DETAIL DESIGN ROAD SAFETY AUDIT
SH1 WAIKATO EXPRESSWAY 110 KM/H SPEED
REVIEW PROJECT HAMPTON DOWNS

PREPARED FOR WAKA KOTAHI NZ TRANSPORT AGENCY

29 September 2021

Figure 1: Proposed edge details

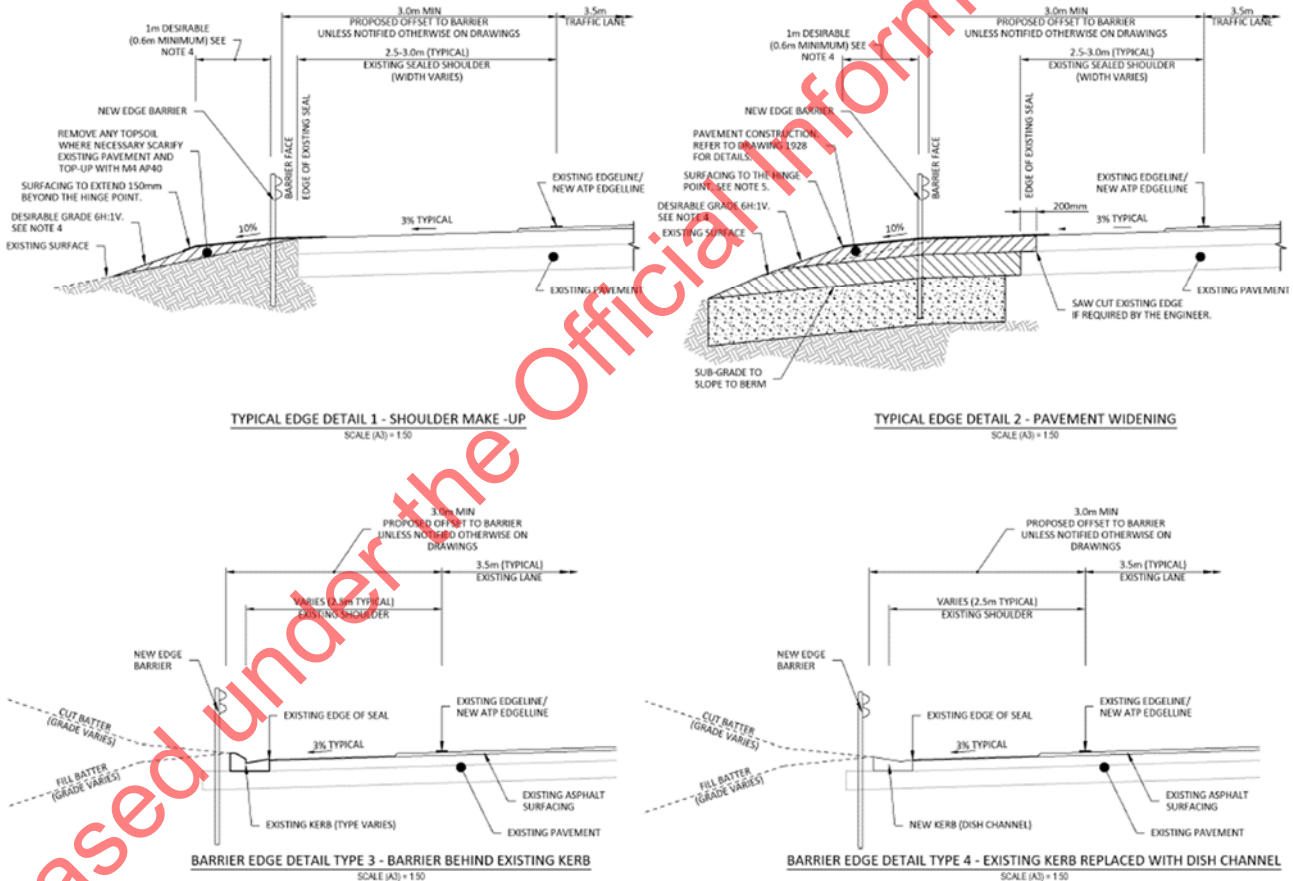
The design philosophy statement and the typical edge details on drawing 147130-02-1901 indicate that, although the existing shoulder next to kerbs is about 2.5 m wide, the barrier will always be installed with a 3.0 m minimum offset from the edge line. Where there are no kerbs, the seal is proposed to be widened to 3.0 m. The design philosophy statement states that, '...for 110 km/h retro fit projects is to retain existing lighting where practicable. Where existing columns are in front of or clash with new barrier, they will be relocated behind the new barrier clear of the deflection zone.' The general arrangement drawings tabulate exactly where each edge design applies. Thus, in all cases, there should be enough width for a vehicle to stop and for the passenger door to be opened.

However, the lighting columns that would need to be relocated are not identified on the drawings, thus placing the onus on the contractor to determine which ones are to be shifted. There is also no criterion shown for how close the barrier can be to the lighting column before it needs to be shifted. Theoretically, the drawings could allow the back of the barrier to touch the lighting column.

The safety concern is that the desired 3.0 m width will not eventuate if it is left to the contractor to determine which lighting columns are to be relocated, especially if the existing lighting column position is only just shy of meeting the requirements and the barrier is shifted to miss the column or to achieve the desired clearance to the lighting column. The two lighting columns, each about 40 m behind the nose of

the two exit ramps, are examples where the flare of the barriers meeting the crash cushions needs to be accounted for.

1. Show the lighting columns on the typical edge details with the minimum acceptable gap between the back of the barrier and the face of the lighting column dimensioned, and also on the general arrangement drawings, so that there can be no ambiguity concerning which lighting columns are to be relocated and which can remain in place.

Frequency Crashes are likely to be infrequent	Severity Death or serious injury is likely	Rating The safety concern is moderate
Designer response	<p>Designer agrees. The drawings now detail where columns are to be relocated. An additional edge detail has been added to the drawing set for <i>Barrier behind existing kerb – with lighting column</i>. The minimum gap between back barrier and light column is 150mm. Survey indicates there is space to accommodate barrier and 150mm gap between kerb and column in most instance. Where this is not achieved columns are shown to be relocated.</p> <p>The general arrangement plans also note the requirement for lighting to be relocated where the 150mm gap cannot be achieved.</p>	
Safety Engineer comment	<p>Agree with SAT. Designer to add lighting columns to the drawing set.</p> <p>Julian Chisnall, Team Lead Road Safety, Programme and Standards: Current best practice is to provide 1.5m between the back of the barrier system and the front face of the lighting column to mitigate the risk of an errant vehicle deflecting the barrier and striking the column. In locations where the 1.5mtr offset clearance cannot be achieved, 1mtr gap would be acceptable (but not desirable).</p>

Client decision	<p>Agree with SAT and RSE.</p> <p>Scope to include the relocation of light columns beyond the barrier deflection zone (min 1mtr gap).</p>	
Action taken	<p>The design has been updated, indicating the relocation of affected light columns</p>

Figure 2: Maintenance access bay Type 2

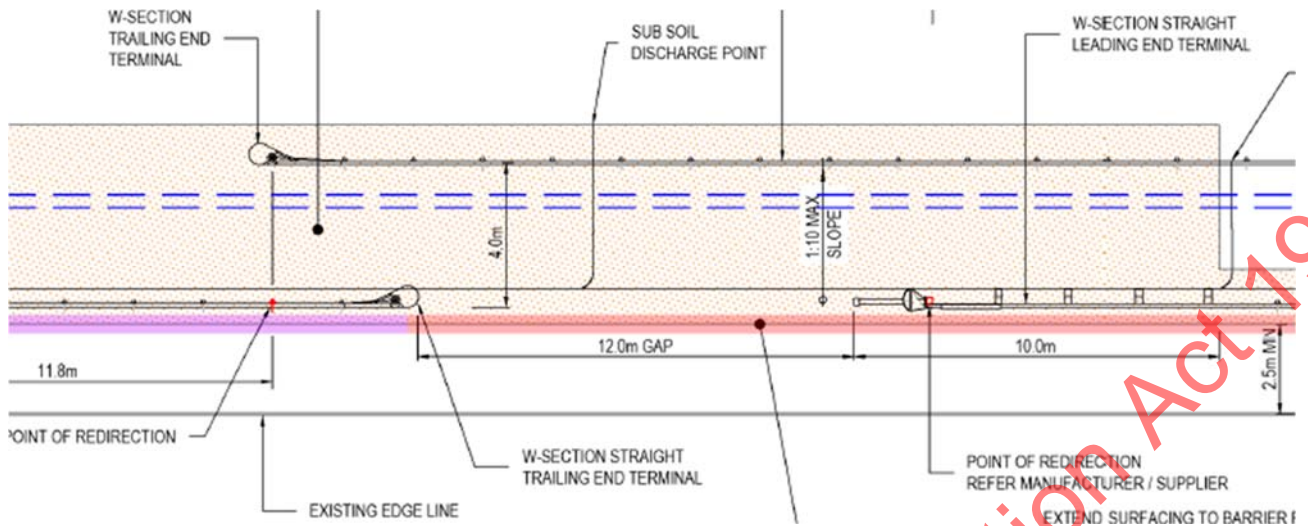
The proposed Type 2 maintenance bay, which is intended to give access to the berm in both directions, is shown in Figure 2.

The effective width of the maintenance bay would be less than the 4 m width shown when the widths of the end terminals are taken into account. There is thus unlikely to be enough width for a maintenance truck to manoeuvre into the maintenance bay from the shoulder and a portion of the through lane will likely be required for the manoeuvre. Similarly, exiting the bay might require the front of the vehicle to swing wide into the adjacent lane. This would mean blocking the through lane while manoeuvring in or out, effectively bringing all traffic in that lane to an unexpected halt. This would be unsafe, not only for the general traffic, but also for the maintenance personnel.

The possibility of using a lane closure traffic management plan with attenuation vehicles was discussed. However, the risk is that a maintenance person might try to use the bay not realising that it required a special temporary traffic management plan.

Furthermore, the gap in the roadside barrier will leave any worker or vehicle in the maintenance bay exposed to the risk of a vehicle leaving the road at that point.

1. Amend the design to a disengaging overlapping barrier layout that will allow maintenance vehicle drivers to pull over onto the shoulder first and then access the maintenance bay without encroaching into the adjacent through lane, while also fully shielding the maintenance vehicle and any personnel in the maintenance bay. This may require additional access bays or alternative arrangements to service the berm.

Frequency	Severity	Rating
Crashes are likely to be infrequent	Death or serious injury is likely	The safety concern is moderate
Designer response	The Type 2 layout has been removed and replaced with a Type 1 layout. The Type 1 layout allows the vehicle to pull onto the shoulder and reverse into the maintenance bay where they are isolated from the main carriageway by w-section barrier.	
	The shoulder is widened to 3.5m on approach and departure from the maintenance bay to allow additional space to enter and exit. The 3.5m width includes a traversable dish channel to replace kerb and channel where required.	
Safety Engineer comment	Concur with SAT and Designer. Type 1 layout supplied by the designer addresses the concerns raised by SAT.

Client decision	Agree with SAT, Designer and RSE. The type 1 layout has been included within the scope.
Action taken	No further action required
